ED-HMI3630-116C

PCN

by EDA Technology Co., Ltd

1 Product Change Notice 1

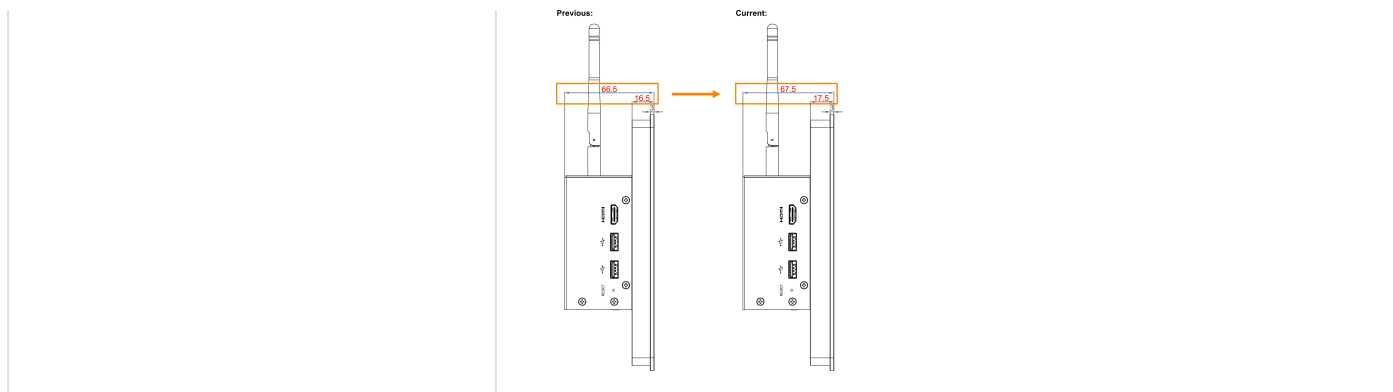
Changes	Results
LCD bezel thickness increased by 1mm	We have optimized the LCD bezel structure to provide additional clearance for internal cable routing. - LCD bezel thickness: adjusted from 16.5mm to 17.5mm. - Total product thickness: correspondingly adjusted from 66.5mm to 67.5mm.
